ADDENDUM No. 2

RFP No. 25-12

State Street Improvements Project

TYPICAL SECTIONS - STATE ST

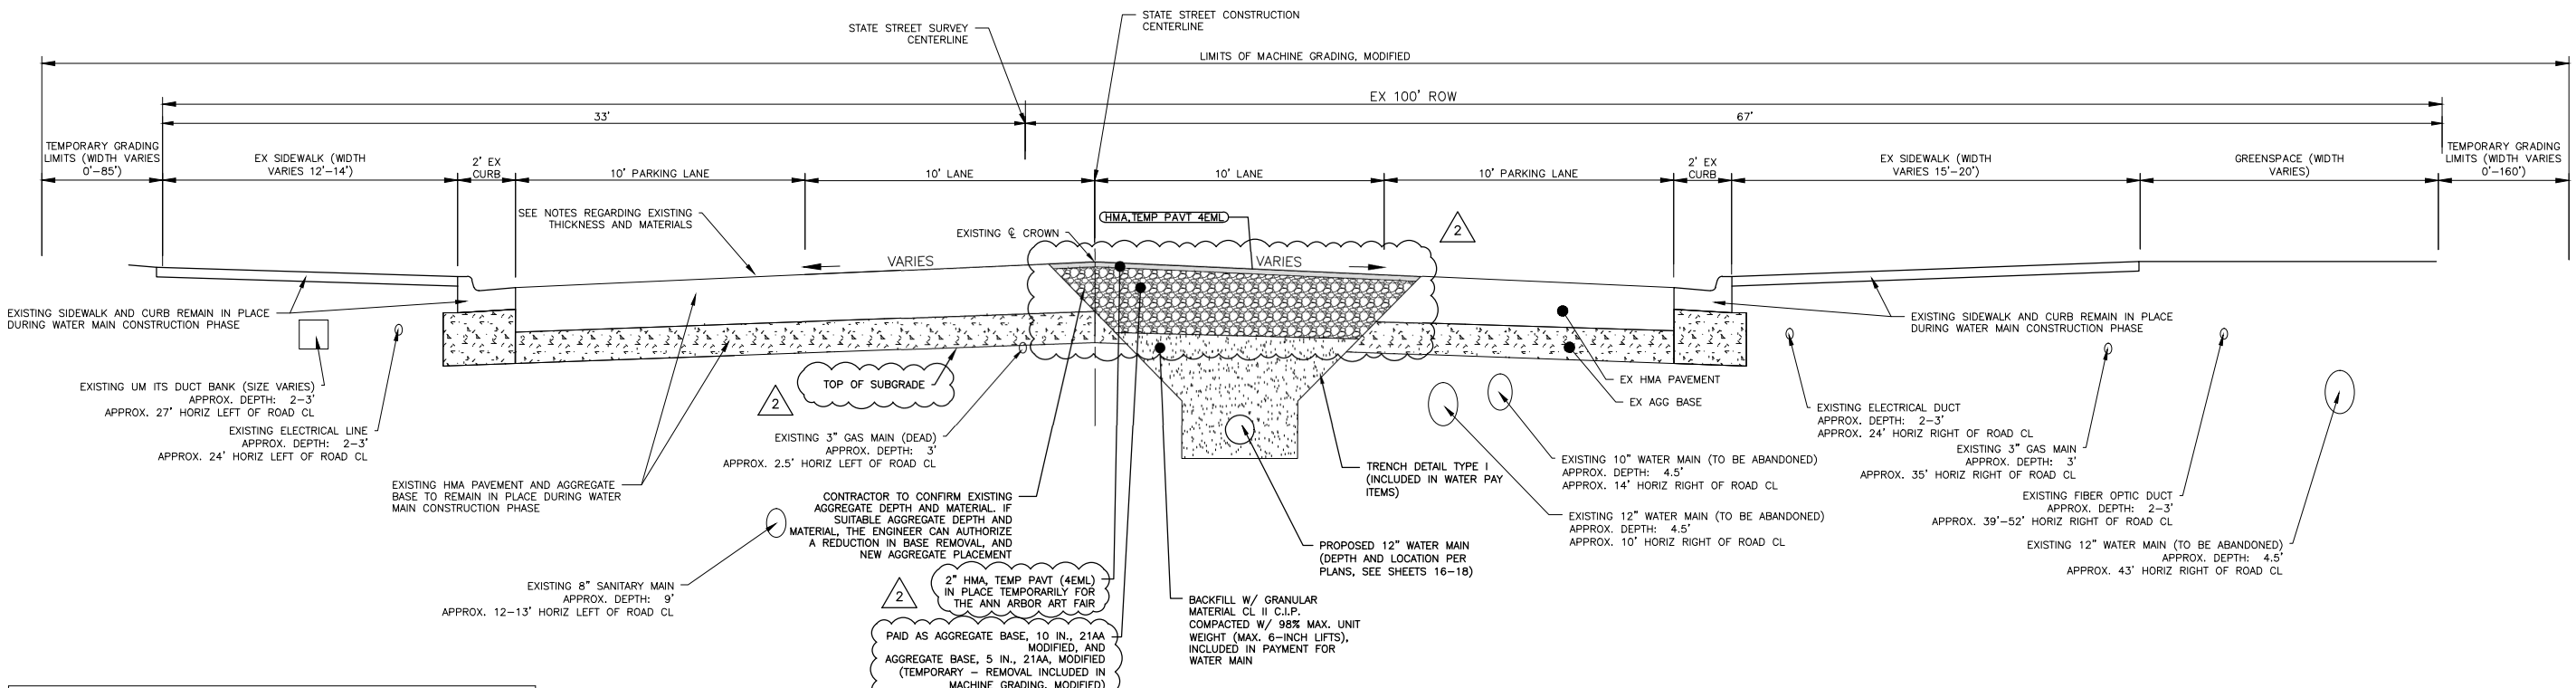
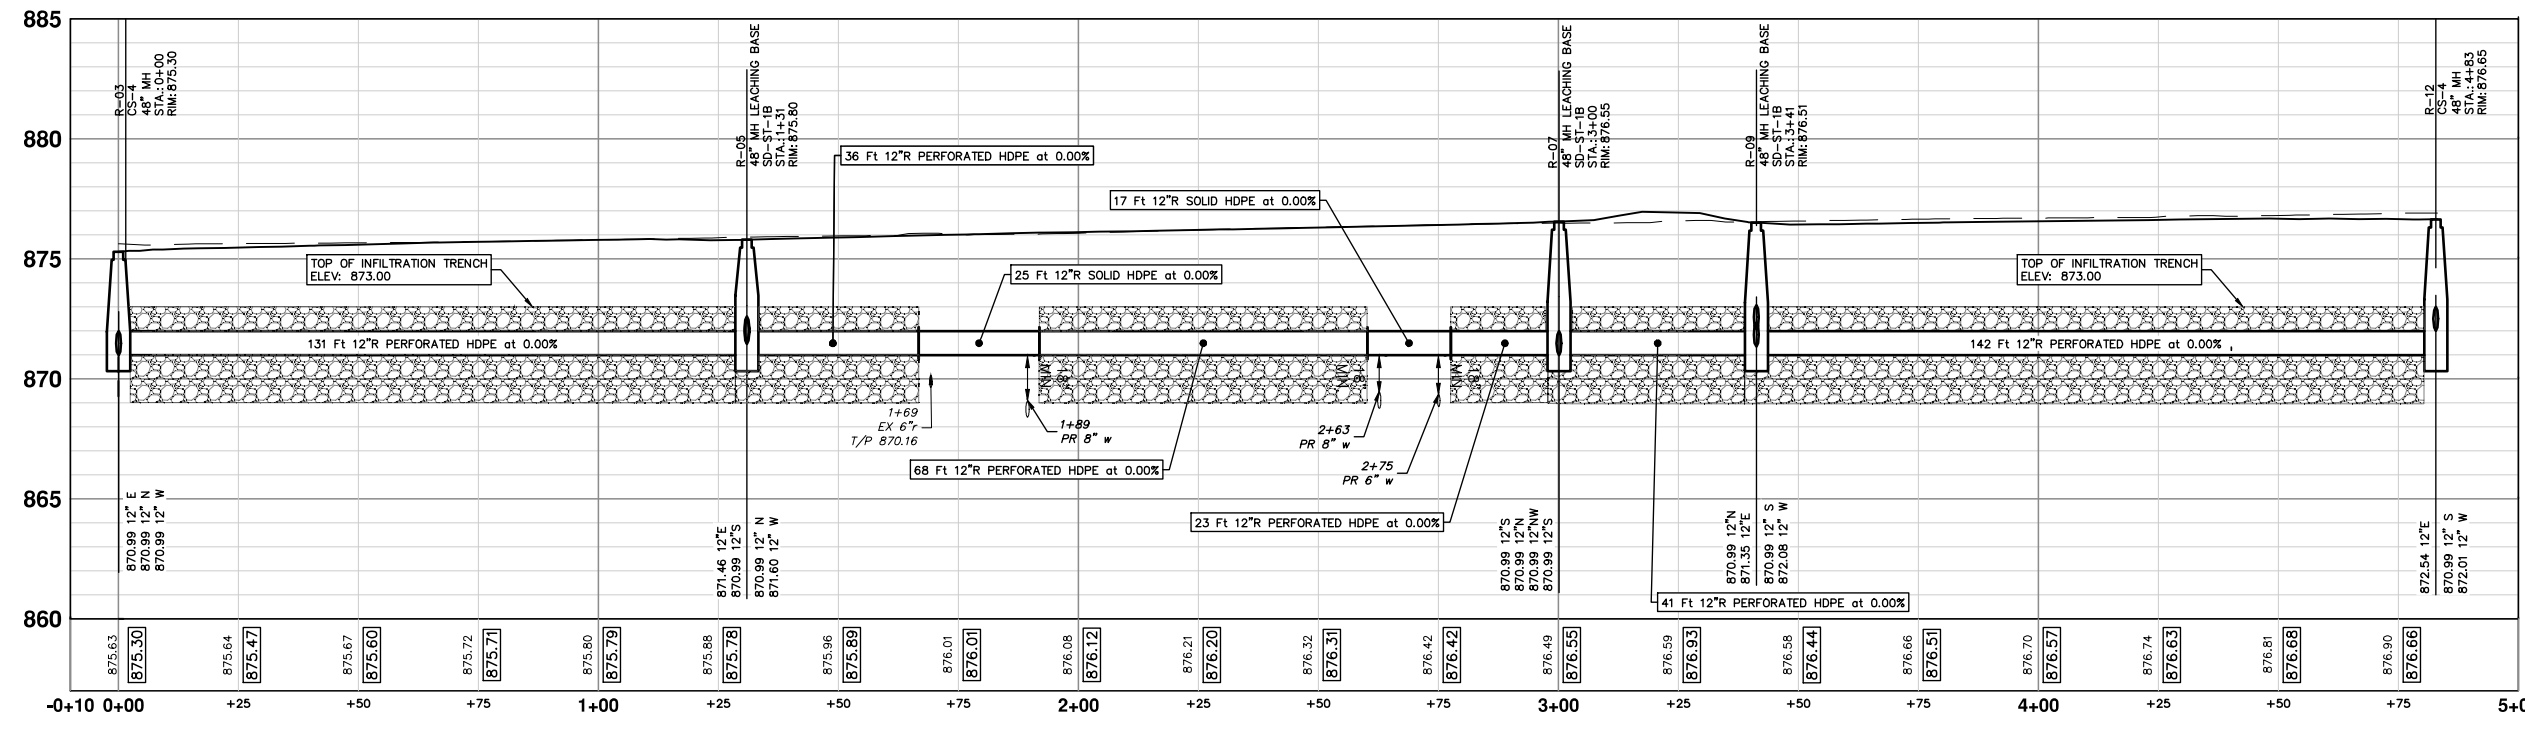
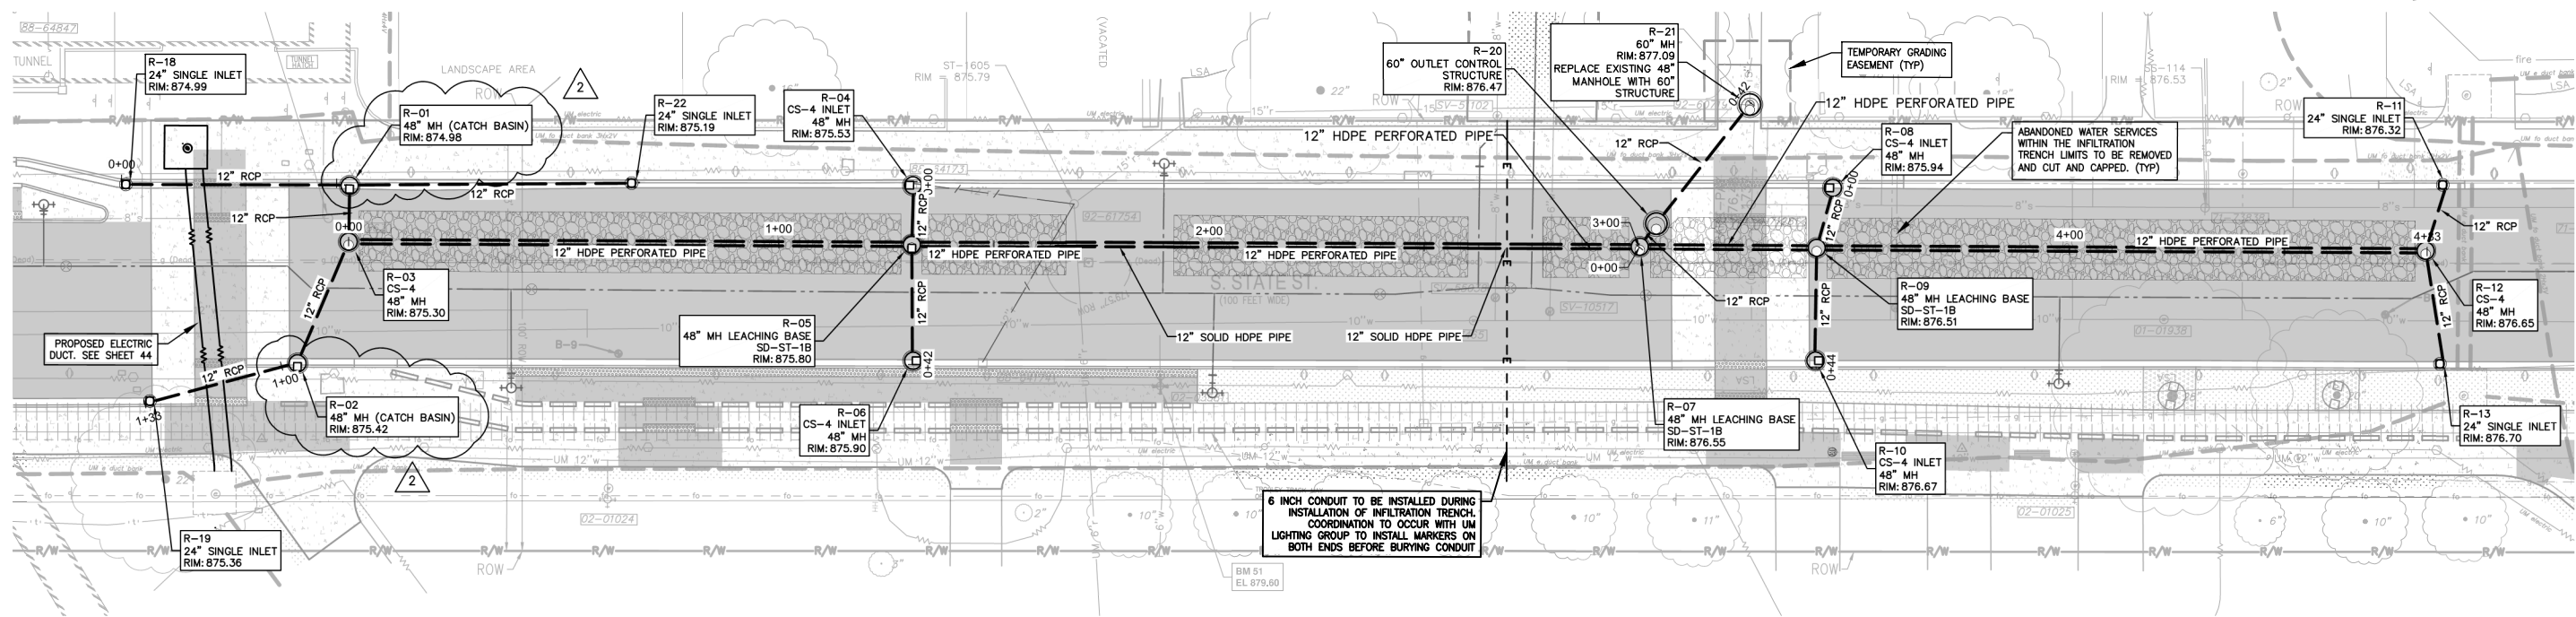
Question 33: On sheet 20, on the x-section, it shows a note that "excavate to the bottom of existing aggregate base, included in machine grading." If going off the borings, this will create more fill. Can you confirm this note is correct?

Answer 33: The note has been changed on Sheet 12 to excavate to planned subgrade.

STORM SEWER PROFILE: R-18, R-01, R-03, R-02, R-19

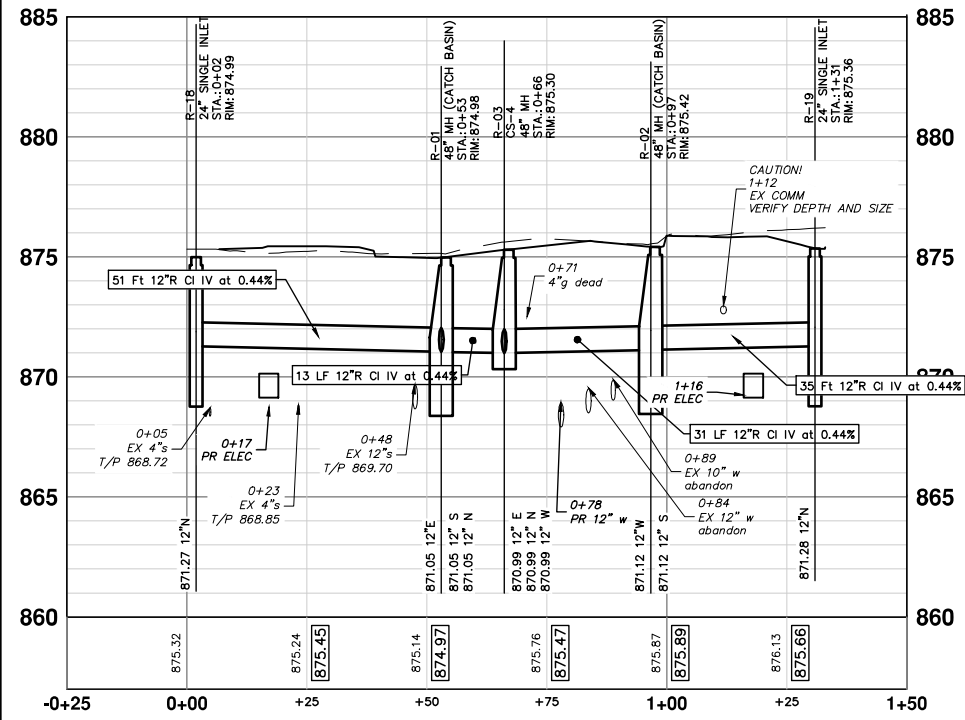
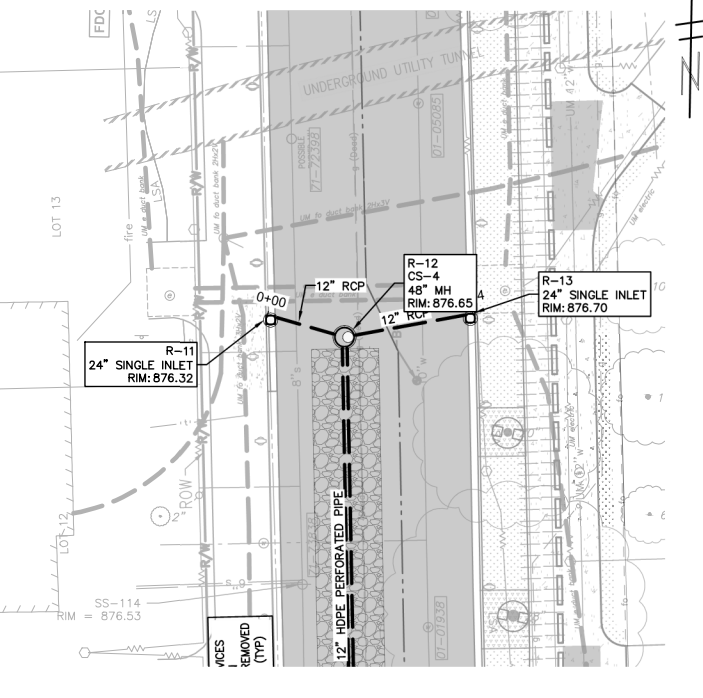
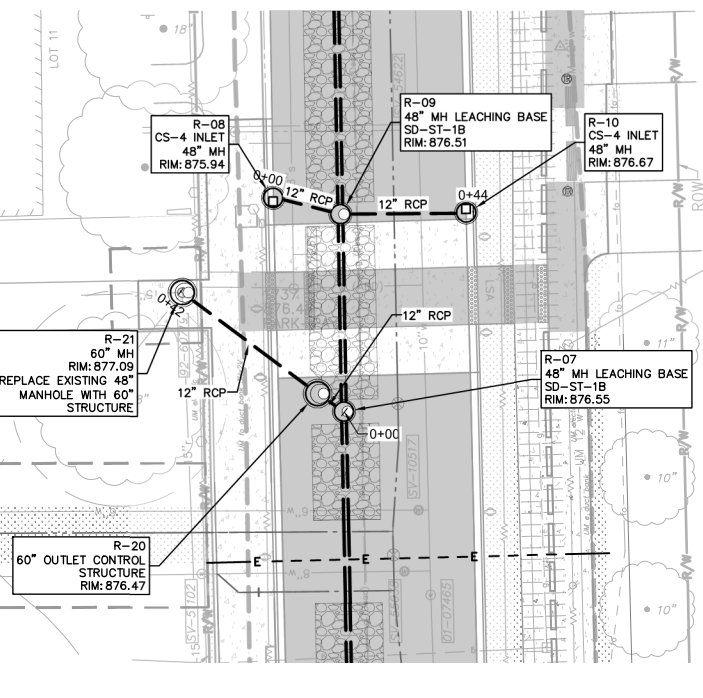
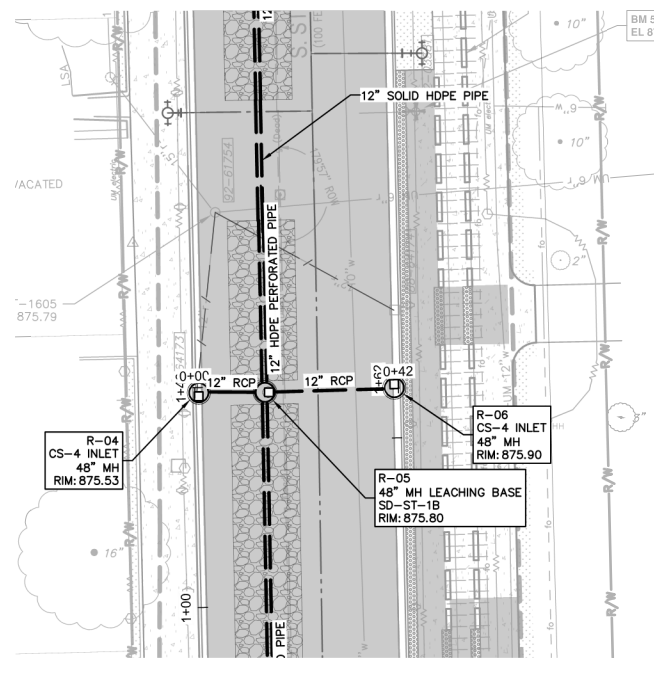
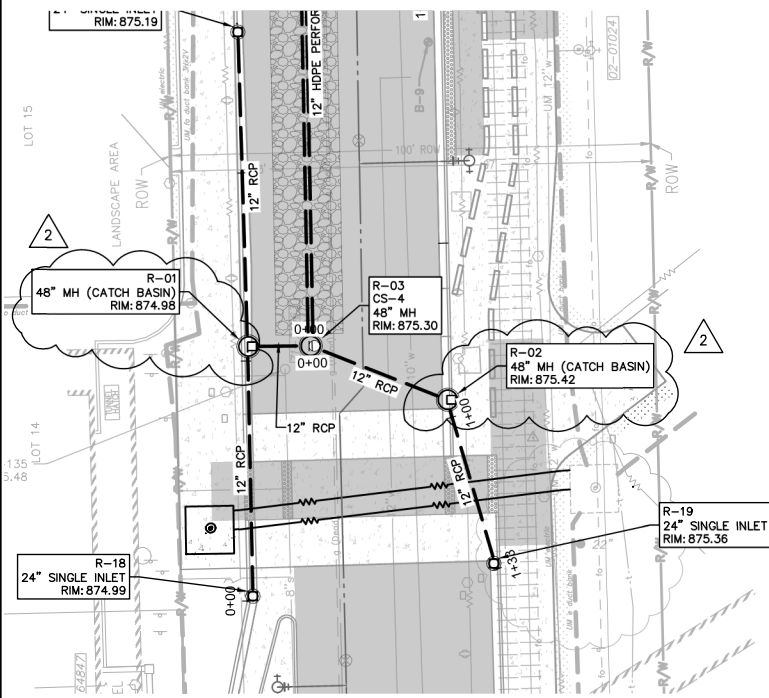
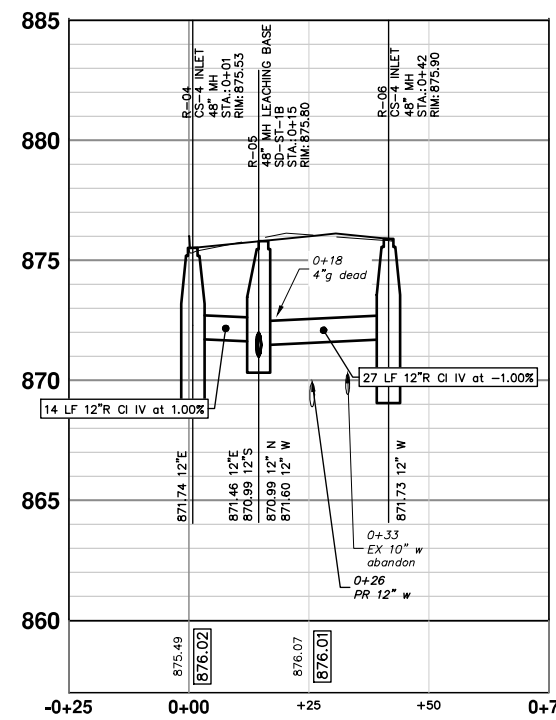
Plan Sheets 41 - 42	Updated proposed storm plan and profile sheet to reflect changes to structures R-01 & R-02.
Plan Sheets 45 – 47	Updated proposed road construction plans to reflect changes to locations of pay item <i>DS_Trapezoid Delineator, Any Size</i> .
Plan Sheet 48	Grade changes to the southbound bus stop.
Plan Sheet 53	Grade changes to the southbound bus stop.
